Request for Additional Information No. 406(4683, 4664, 4707), Revision 0

U. S. EPR Standard Design Certification
AREVA NP Inc.
Docket No. 52-020
SRP Section: 09.02.02 - Reactor Auxiliary Cooling Water Systems
SRP Section: 09.04.01 - Control Room Area Ventilation System
SRP Section: 09.05.01 - Fire Protection Program

09.02.02-112

Response to Question 09.02.02-112:

The CCWS surge tank volume and level design is as shown in the figure below.

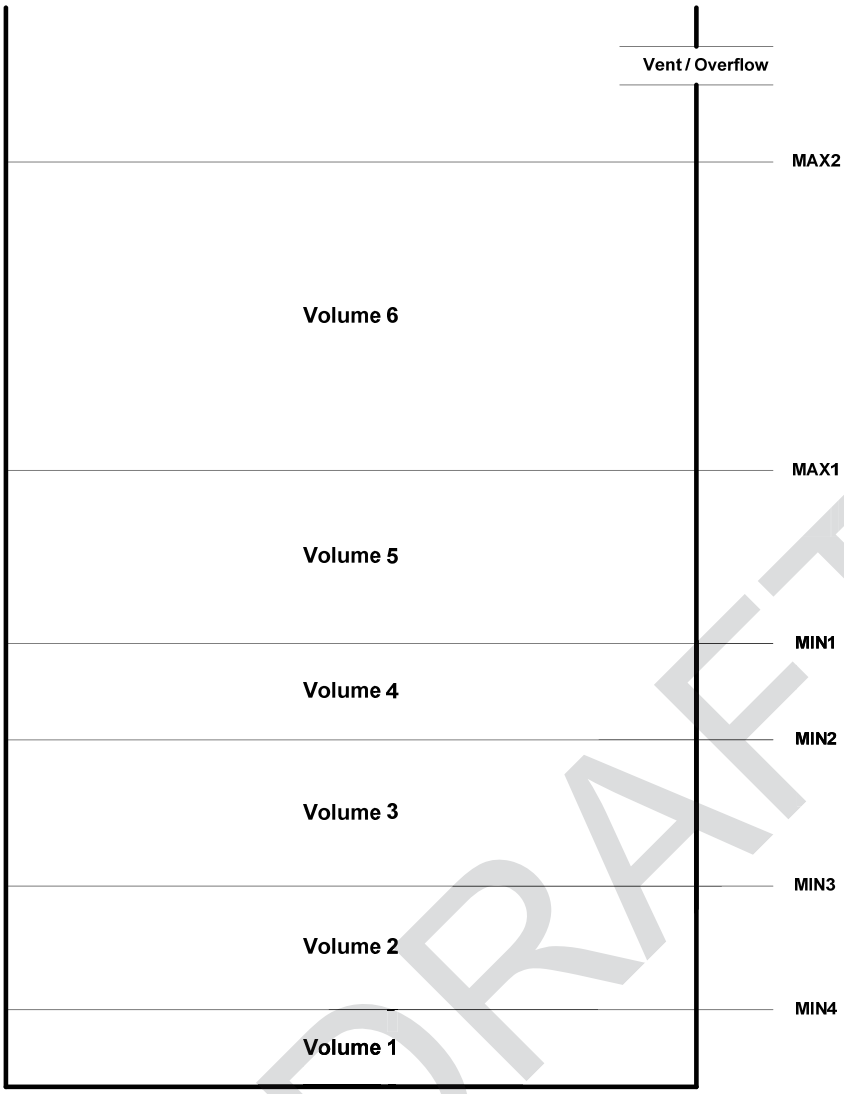
a. Describe the surge tank level at the start of the scenario knowing that the non-safety make-up starts to make-up at MIN1 (if available) as described in Tier 2 FSAR Section 9.2.2.6.1 and that the non safety users isolate at MIN2 (based on delta flow) and switchover valves do not isolate until MIN3 is reached in the surge tank.

b. For Item (C)2, describe the basis for total required makeup volume for 7 days and that continuous outleakage must be assumed for the 7 day period as discussed in SRP 9.2.2.

To set the levels for operating volumes in each surge tank, the following considerations are applied:

- Normal Operating level is between MIN1 and MAX1
- Normal Demineralized Water makeup initiates at MIN1
- Non-Safety users outside of the Reactor Building automatically isolate at MIN2
- Common Header Switchover valves automatically isolate at MIN3
- CCWS Pump trip is at MIN4
- The minimum water level in any CCWS surge tank is calculated per ANSI/HI 9.8 (1998). This level is used to determine Volume 1 for each tank. Volume 1 will vary by tank due to slight variations in dimensions for each tank.
- Volume 2 between MIN3 and MIN4 is a water volume equal to 750 gallons per tank. This is the Post-Seismic 7 day leakage volume. This volume of water between MIN3 and MIN4 allows a CCWS train to run for 7 days on safety injection cooling with no surge tank make-up
- Volume 3 between MIN2 and MIN3 is equal to the system fluid lost during automatic isolation of a pipe rupture.

- Setting MIN1 level in each tank will provide Volume 4. Volume 4 will vary by tank due to varying sizes for each tank.
- Volume 5 is an open space volume allocated for thermal expansion of the CCWS system fluid.
- Volume 6 is an open space volume allocated for in-leakage from a HX tube rupture and offer time for operators to diagnose the malfunction and take action.

Per SRP 9.2.2, III, 3.C time zero for consideration of this post seismic leakage value begins at the low level alarm. For the CCWS design, the low level alarm in the tank is MIN3. MIN3 is the level at which "time zero" begins. At MIN3, seat leakage through the isolation valves for the non-safety related users is not a concern because those valves isolate at MIN2. Those valves are inside of the boundary created by closing the switchover valves at MIN3. Accounting for this post-seismic leakage allowance between MIN3 and MIN4 provides the CCWS with adequate capacity to operate for 7 days without reaching the MIN4 level which trips the CCWS pump.
